**3 Detailed description of change**

Product Change Notification					PCN for PG05 (Change Config.Code)		
owner	creation date	release date	released by	change order no	rev	page	D10-024-451
hollenpe	28.03.2018	05.07.2018	limachcl	2015365	A	1 of 2

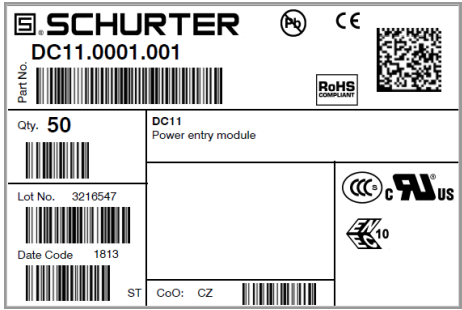
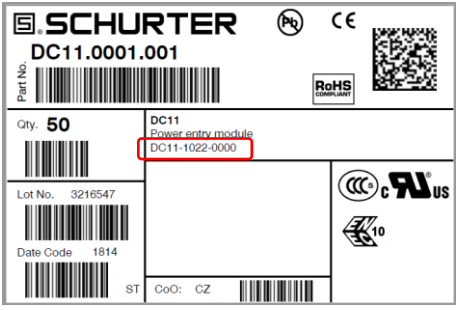
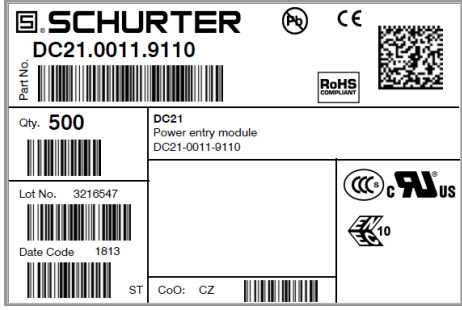
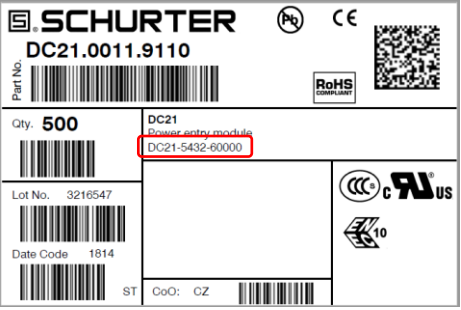
The configuration code has been modified. This change affects all the configuration codes depicted in documents by SCHURTER AG which refer to the affected products. This includes the packaging label and documents created in SAP(e.g. invoices, order papers, etc.). None of the part numbers will be altered and will remain the same as before. To secure a unique reference, SCHURTER asks the customer to refer to the part number for future correspondence. The configuration code can be used as a second reference to identify the technical properties of a product. Please check the list "Change of configuration code PG05\_06\_07" for a reference of the old and new configuration code with the according part number. You can find said list in the SCHURTER Partner Service on our website.

Old packaging label (without old CC)	New packaging label (with new CC)
 <p>Part No. DC11.0001.001 Qty. 50 Lot No. 3216547 Date Code 1813 DC11 Power entry module CoO: CZ</p>	 <p>Part No. DC11.0001.001 Qty. 50 Lot No. 3216547 Date Code 1814 DC11 Power entry module DC11-1022-0000 CoO: CZ</p>
Old packaging label (with old CC)	New packaging label (with new CC)
 <p>Part No. DC21.0011.9110 Qty. 500 Lot No. 3216547 Date Code 1813 DC21 Power entry module DC21-0011-9110 CoO: CZ</p>	 <p>Part No. DC21.0011.9110 Qty. 500 Lot No. 3216547 Date Code 1814 DC21 Power entry module DC21-5432-60000 CoO: CZ</p>
